PLN23-094

Additional Information

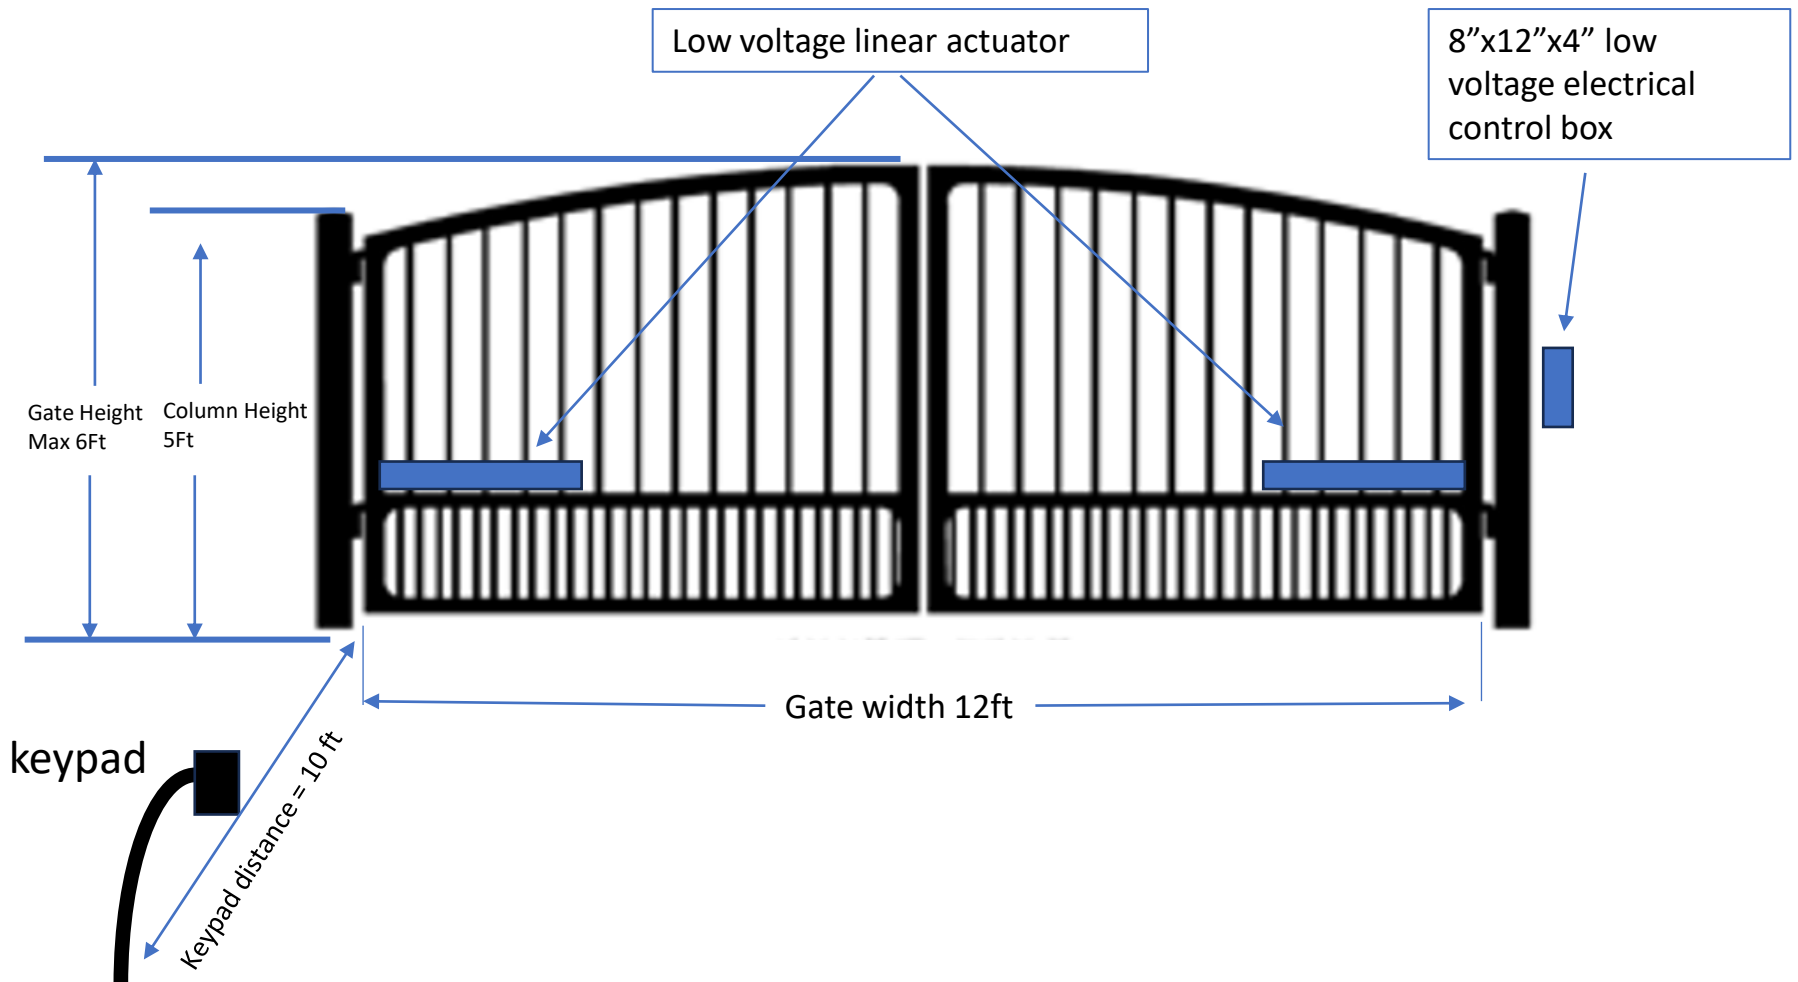
1) Please provide images of the gate as-built

2) Please show the location of the electrical Equipment and keypad/pass

Elevation Plan

Note: gate setback from property line = 25 feet

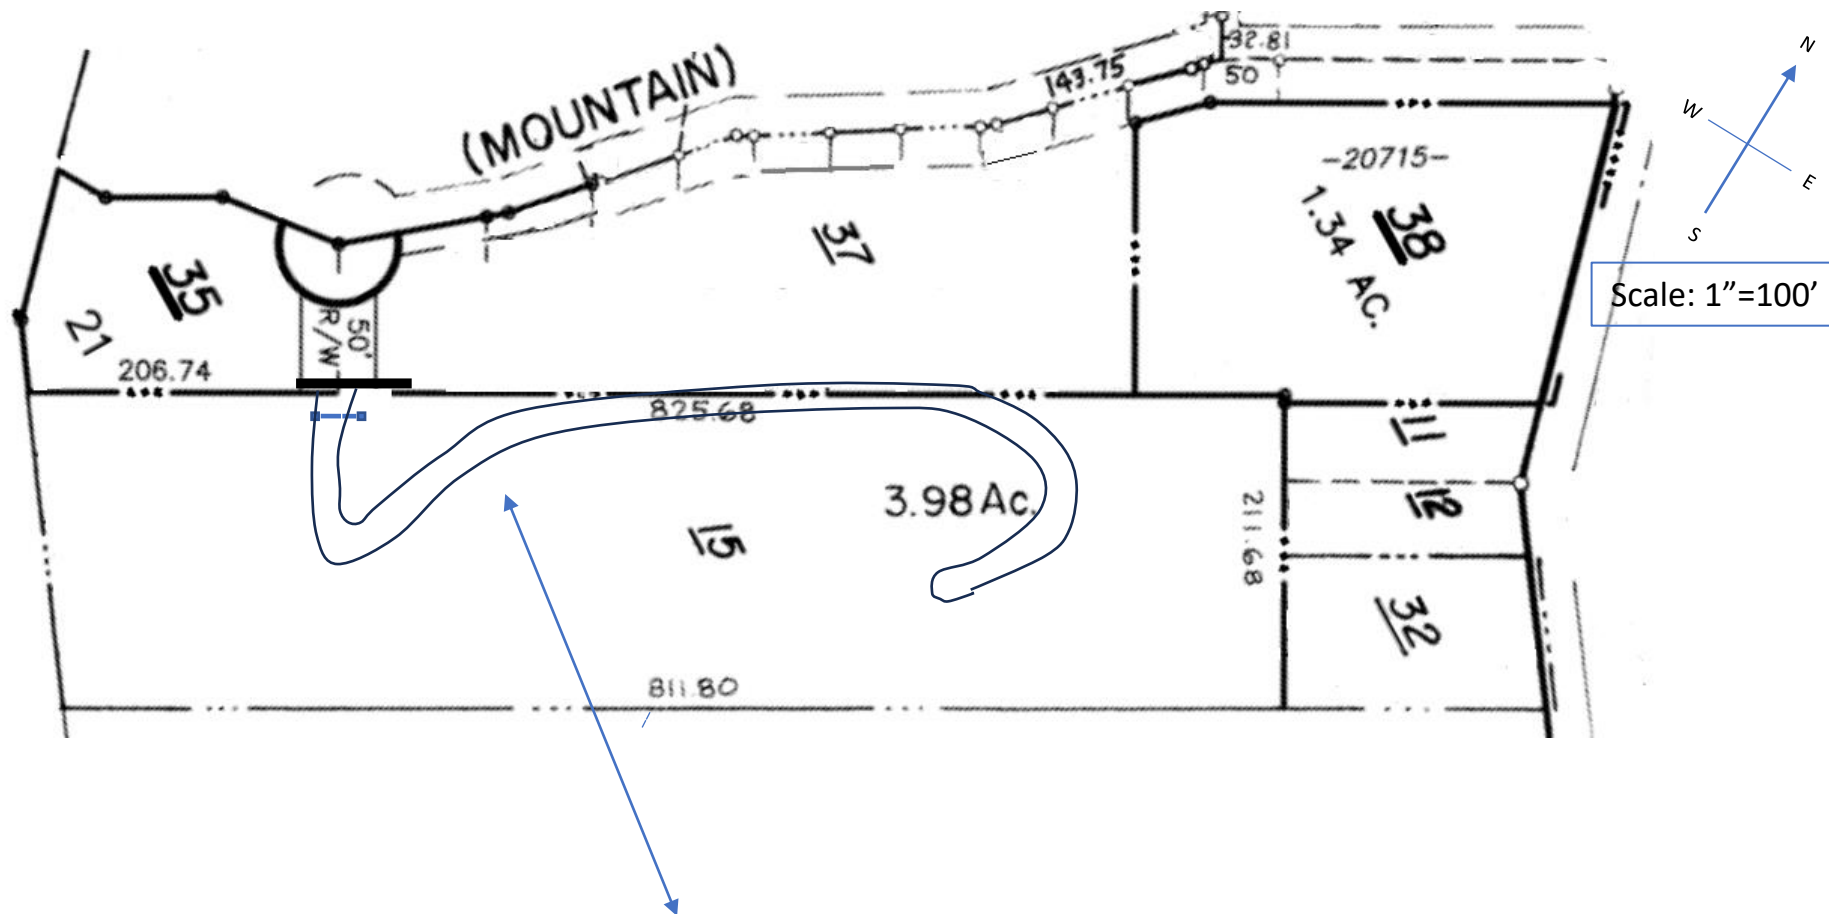
3) Please include the paved area (driveway) on the site plans

100% of Mountain drive and the driveway for 20799 is covered with pavement

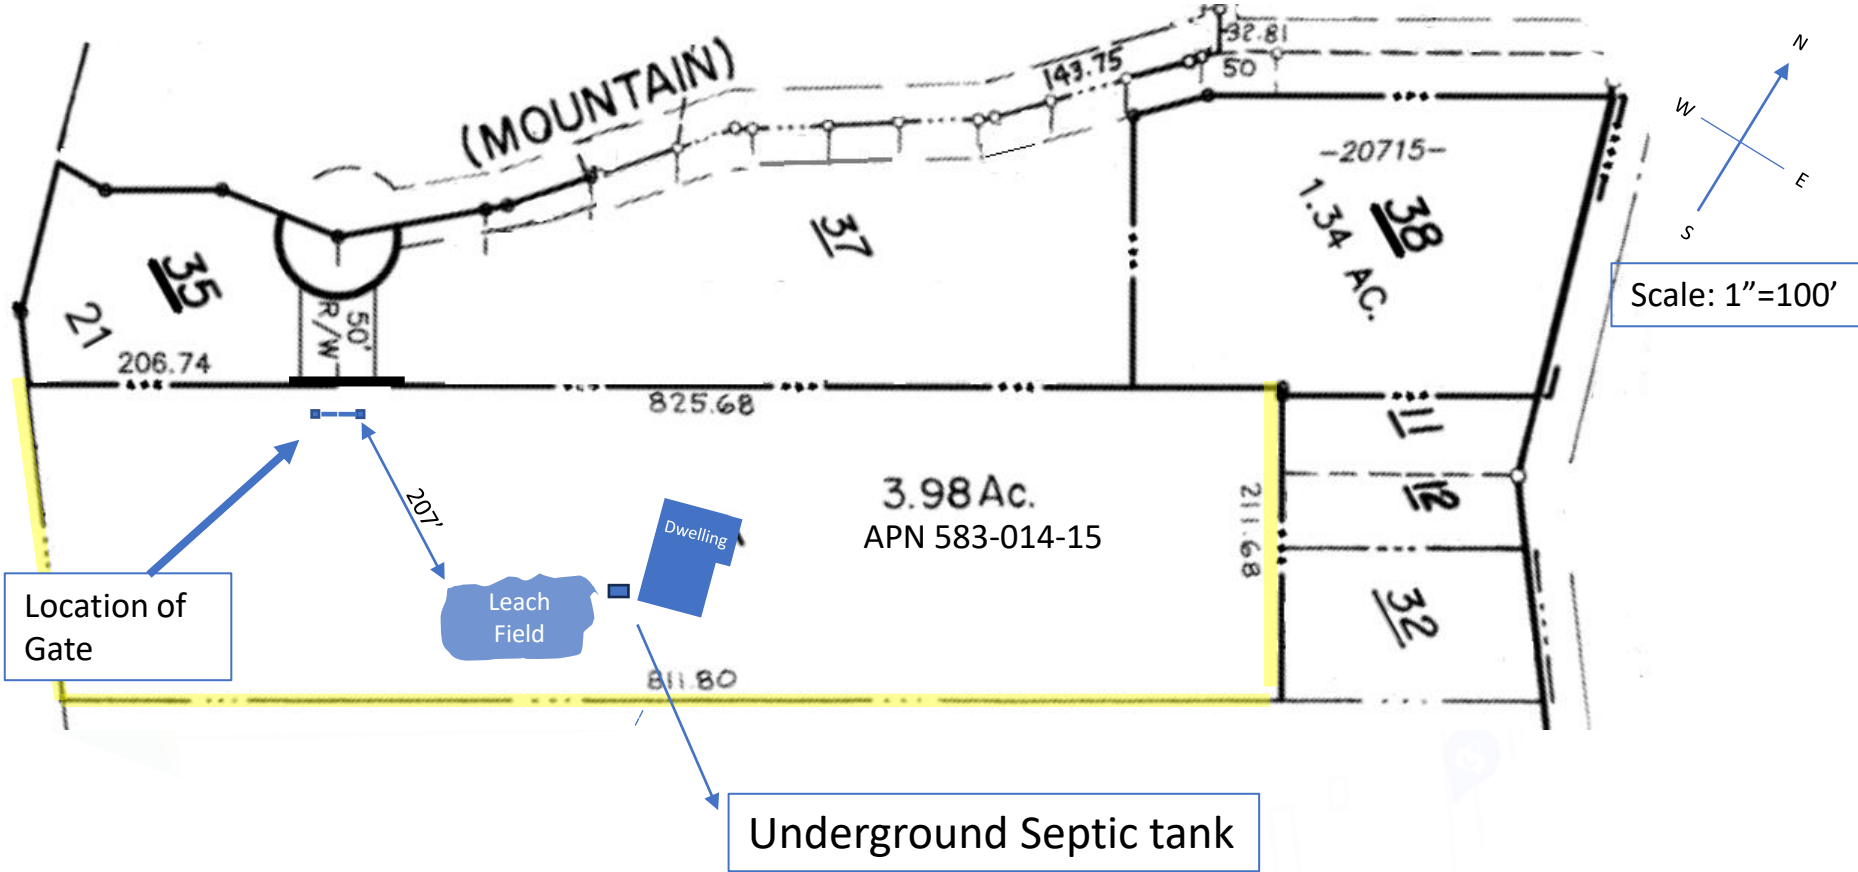
5) Accurately locate and show the location of the existing wastewater treatment system

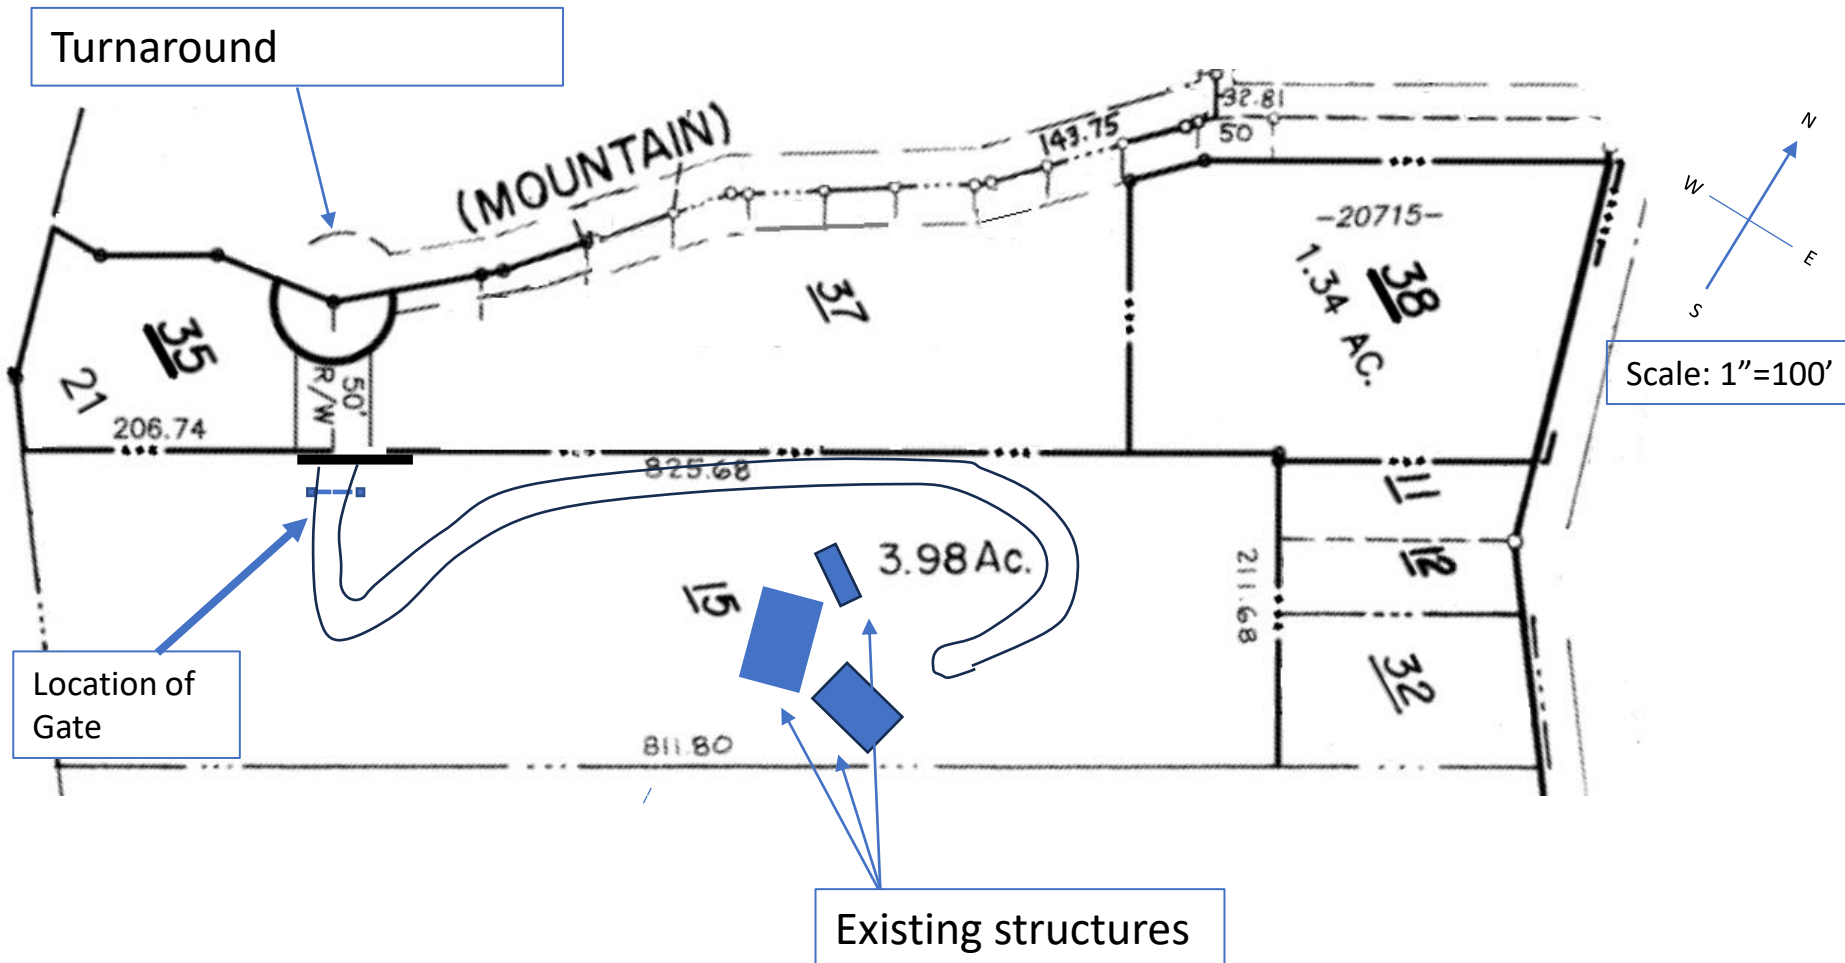
6) Plan that includes the entire site, including the driveway, fire hydrants, turnouts, turnaround and structures. Gate does not affect access to turnouts or turnarounds and is not near any structures: Gate is more than 50 ft from the turnaround and any existing structures.

6 Photo of existing Knox key

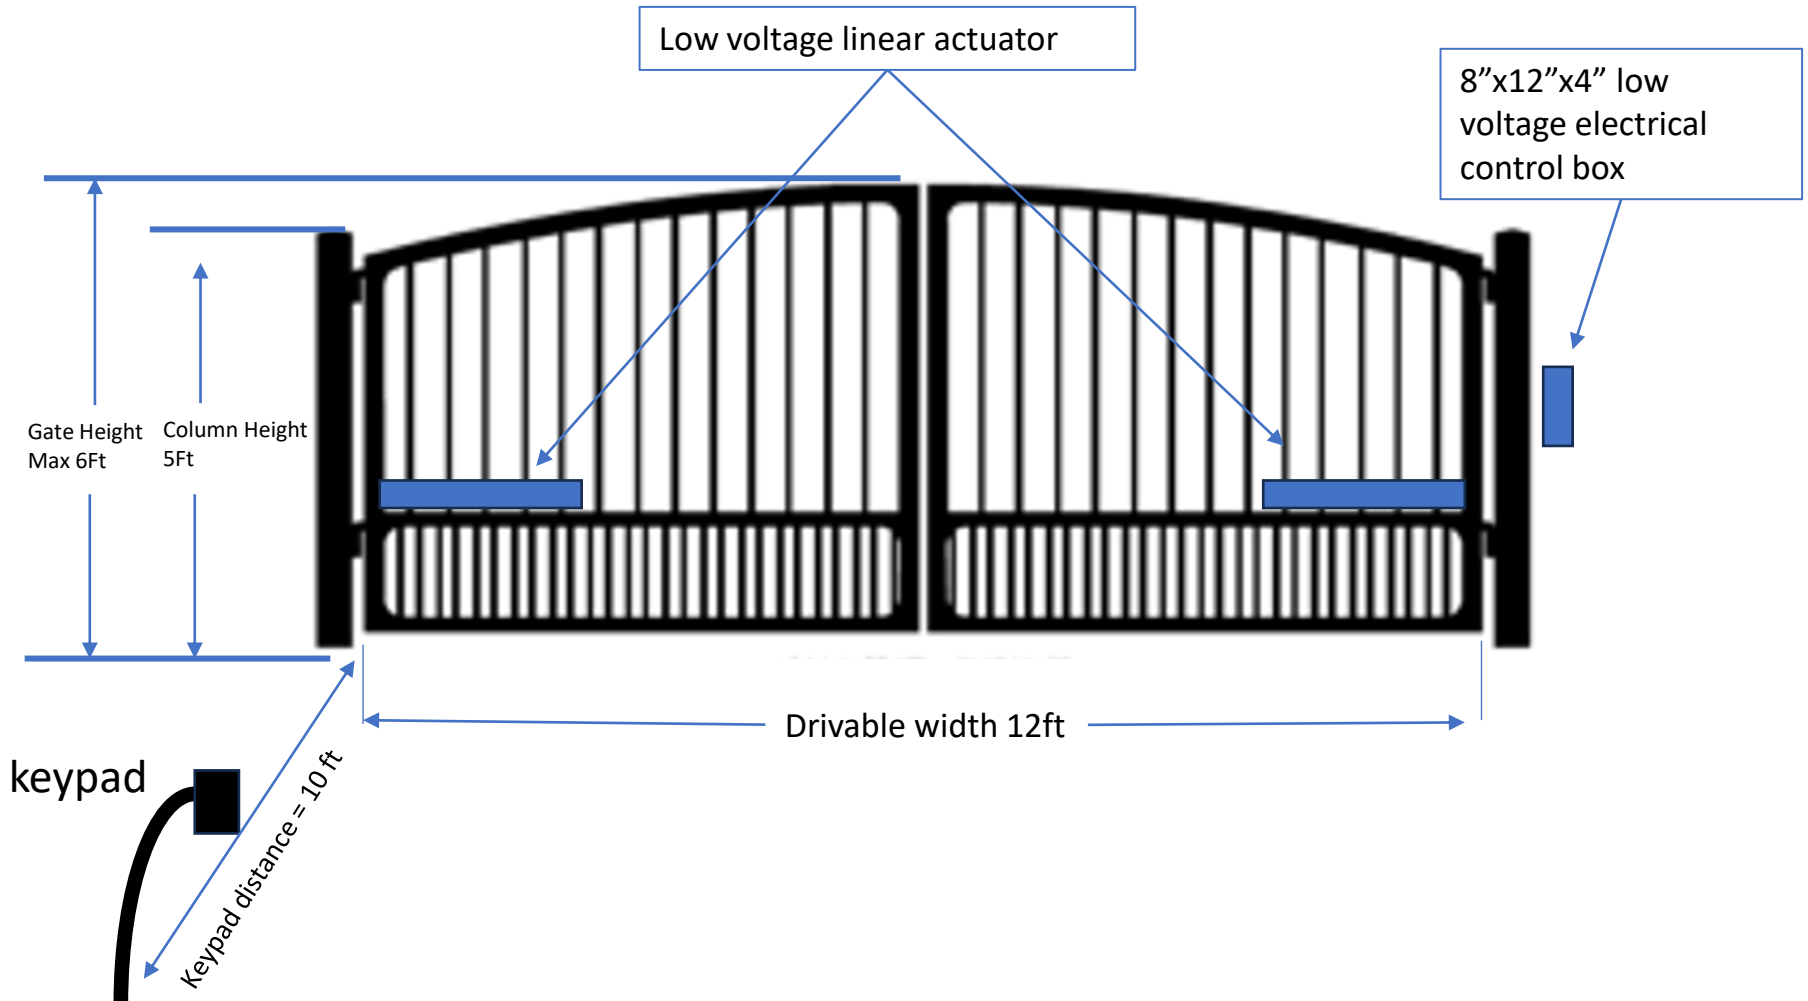
7) Gate is Mechanical , Knox Key Switch located on the keypad, testing documentation not available

8) Clear drivable width of gate meets CFMO-A3 (12 ft)

Note: gate setback from property line = 25 feet
